CITY OF HOOD RIVER

To: Mayor and City Council

From: Planning Commission

Re: Recommendations for Westside Area Concept Plan Frameworks (File No. 2018-07)

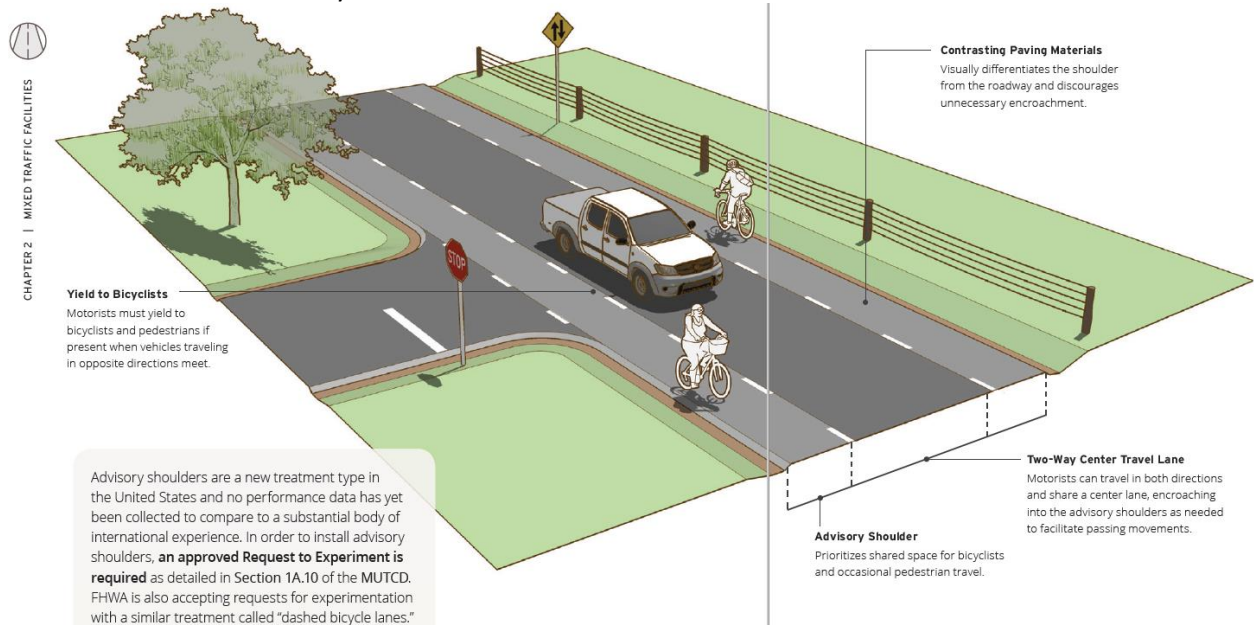
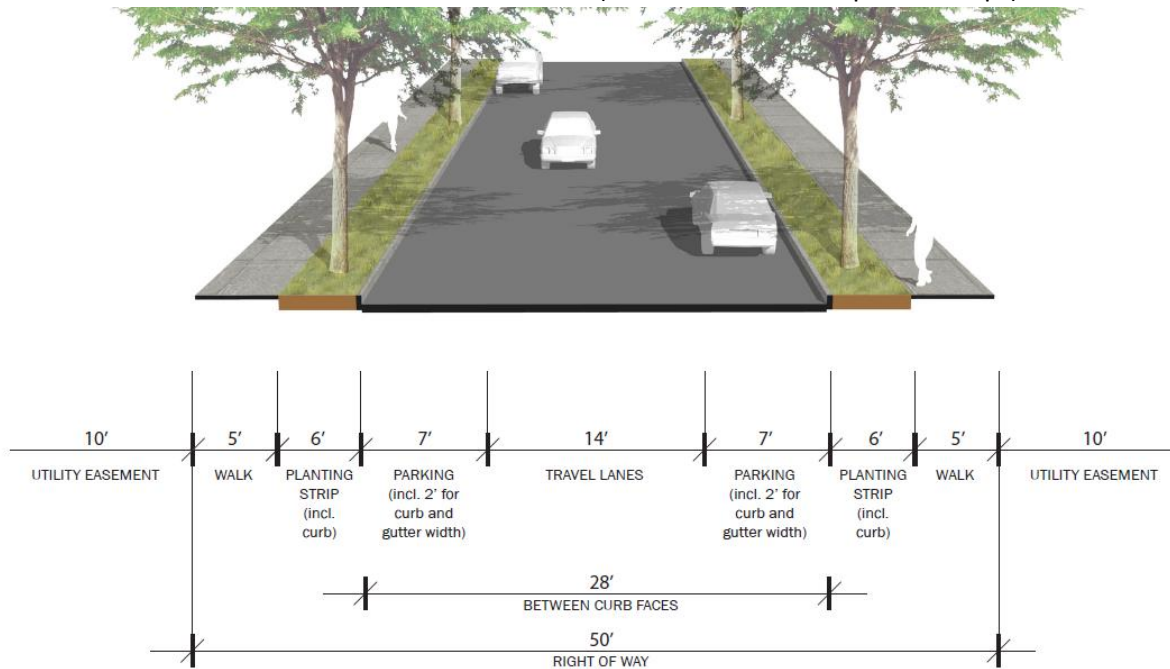
- Revise the proposed Minor Arterial cross-sections (specifically "Alignment D" of the "Mt. Adams extension") to replace on-street buffered bike lanes with physically separated bike lane as depicted in the Federal Highway Administration's "Small Town and Rural Multimodal Networks" publication

(see image below). However, also consider maintenance requirements for physically separated bike lanes. The separated bike lane design is intended to better accommodate novice and younger cyclists, and it provides an additional buffer between vehicles and pedestrians. As depicted in the following image, the bicycle path returns the cyclists back to the road at intersection locations.

- Revise the proposed “Neighborhood Connector” cross section to incorporate “advisory shoulders” where on-street bicycling shares space but is visibly separated from two-way, alternating, vehicle passing movements (see concept below). The cross section should include physically separated sidewalks that are a minimum of 6 feet in width wherever possible. The suggested half-street cross section includes a 6-foot-wide sidewalk, 7-foot-wide planter strip, 7-foot-wide on-street parking, 4-foot-wide bike lane, all used in combination with a single 12-foot-wide vehicle travel lane that accommodates two-way traffic.

Neighborhood Traffic Management Tools

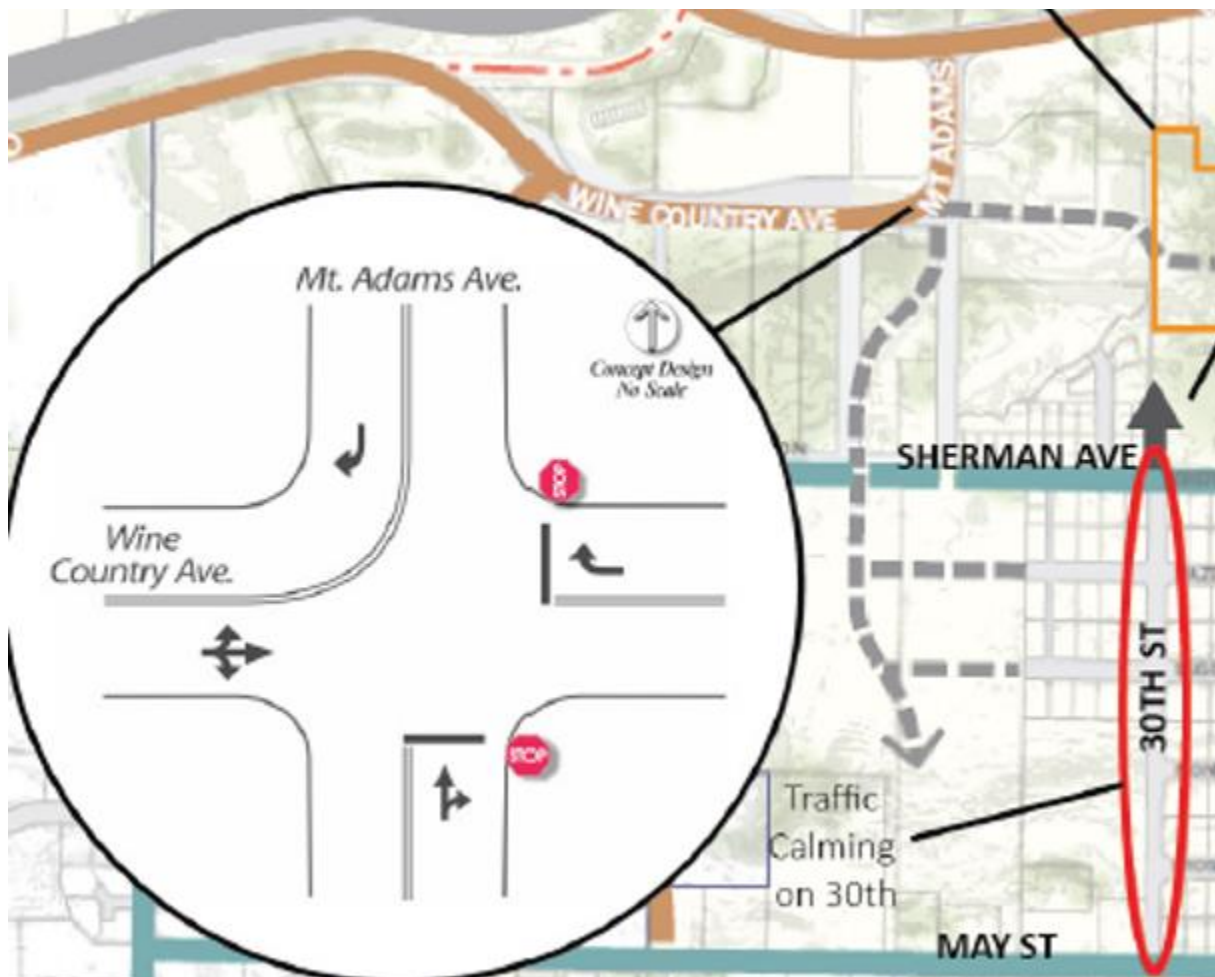
- The Commission supports incorporating traffic calming measures on 30th Street north of May Street to slow and limit cut-through traffic by using specific design features identified in the Concept Plan Report (see examples below). The specific methods and locations of traffic calming measures should be determined by the City Engineer as needed.

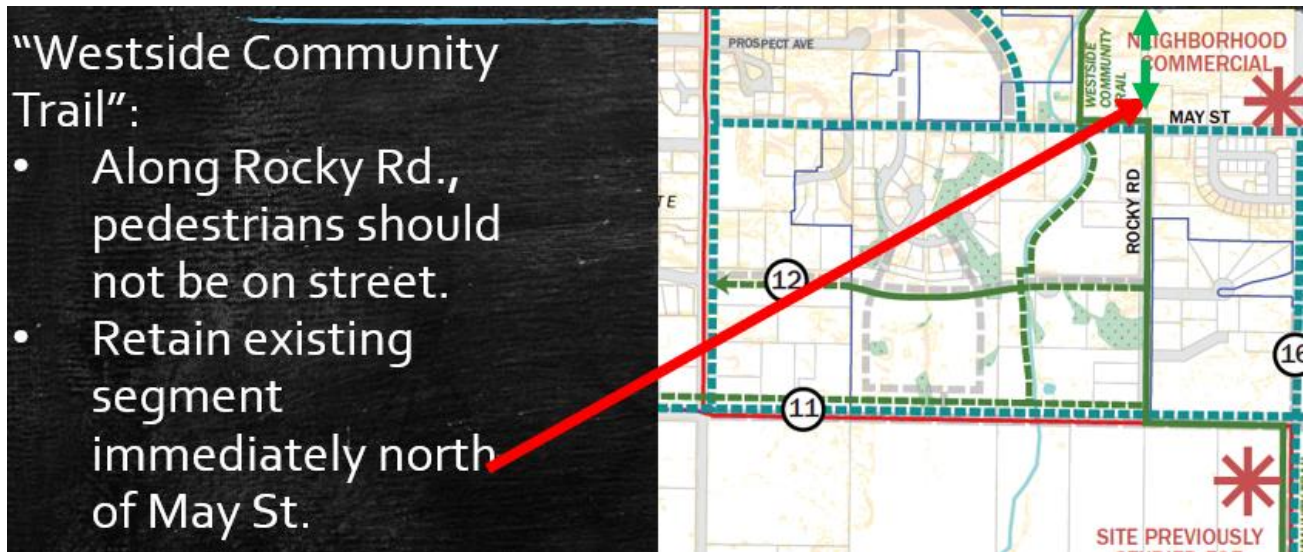
- Establish a Henderson Creek Trail in a buffer along the creek between the UGB (south end) and Cascade Ave. (north end), including where creek may have been piped.

- Correct the alignment of the Henderson Creek Trail on the Pedestrian and Bicycle Framework map so that it follows the alignment of the creek.

"Ridgeline Trail":

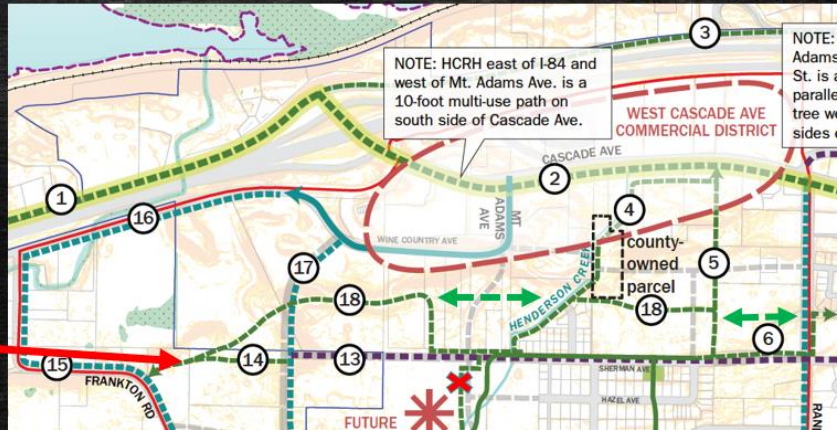
- Establish a Ridgeline Trail in the alignment depicted on the Bicycle and Pedestrian Framework, including adding an off-street connection over the existing Mt. Adams Ave. "road cut," and extending the trail east to Rand Rd.

- Support new trail
- Minimize segments relying on sidewalks with bikes on street (avoid if possible).
- Refinement of location needed near Frankton Rd.

"Westside Community Trail":

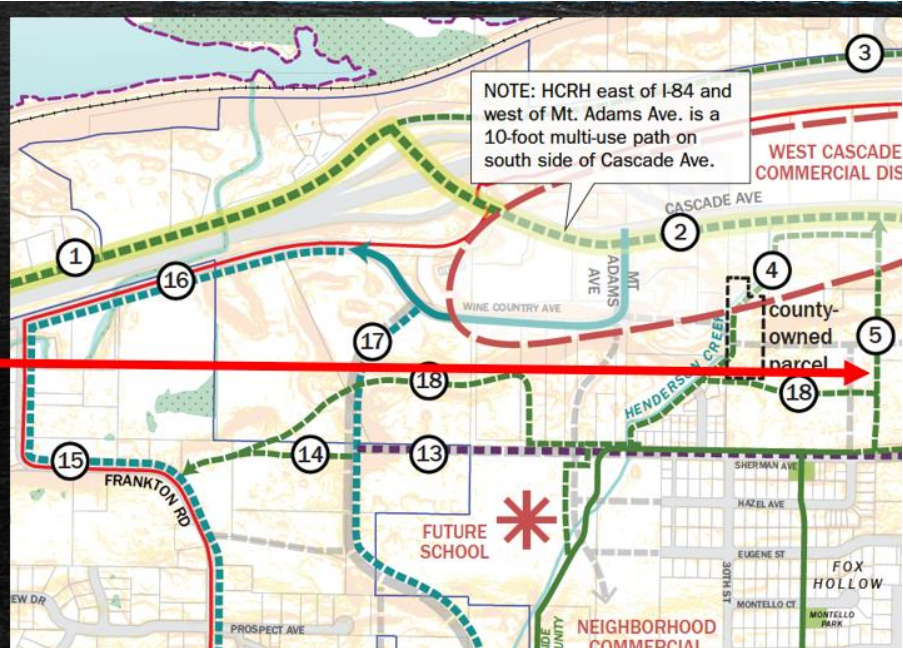
- Change the location of Westside Community Trail east of Frankton Road (portion of Trail 12) to align with Carr Dr. rather than Blackberry Dr. due to nature of existing road easements.

- Trail Segment 12 off of Frankton Rd. should be via Carr Drive rather than Blackberry Dr., through Willow Ponds to Rocky Rd.

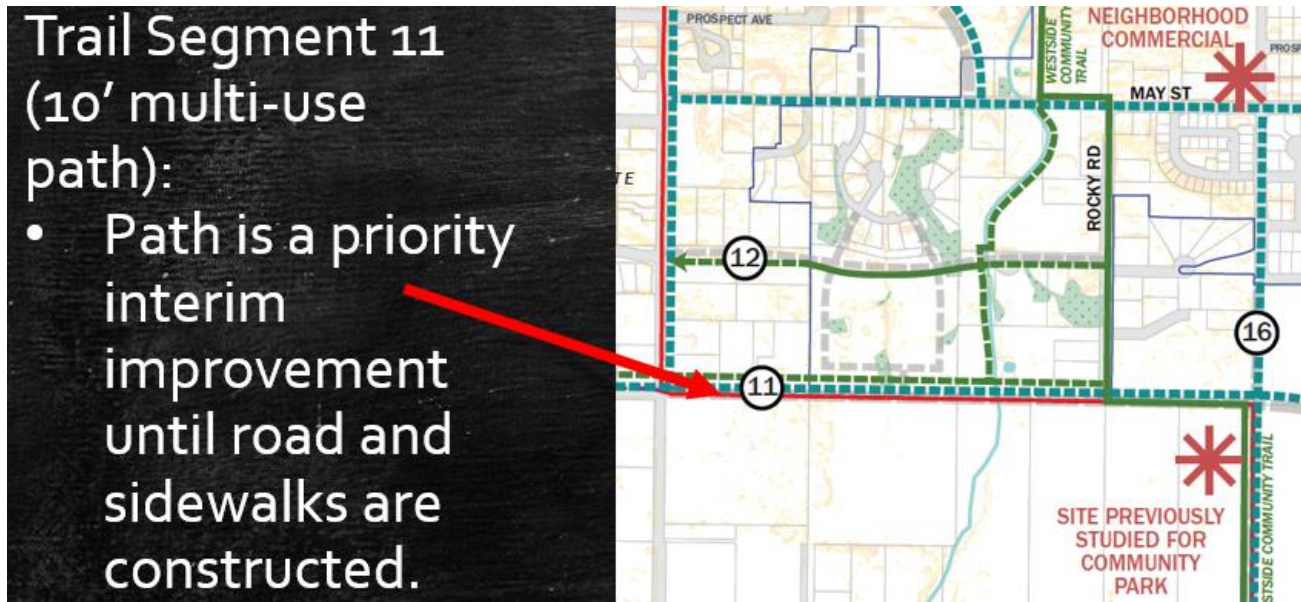
- The Westside Community Trail north of Sherman Ave. (portion of Trail 5) should align with the future Neighborhood Connector street (City Engineer to determine if future street must align with Max's Loop, or if it should be located over existing stormwater utilities).

Trail Segment 5 (4' firm and stable surface):

- May need to include stairs
- Not needed parallel to future Neighborhood Connector street with sidewalks

- A portion of the Upper Terrace Neighborhood path (Path 10) is not needed adjacent to a future Connector Street between May St. and Post Canyon Dr. (however, retain trail segment between Post Canyon Dr. and Belmont Dr.).

Trail Segment 10 (10' off-street asphalt or concrete path):

- Not needed parallel to future Neighborhood Connector street with sidewalks
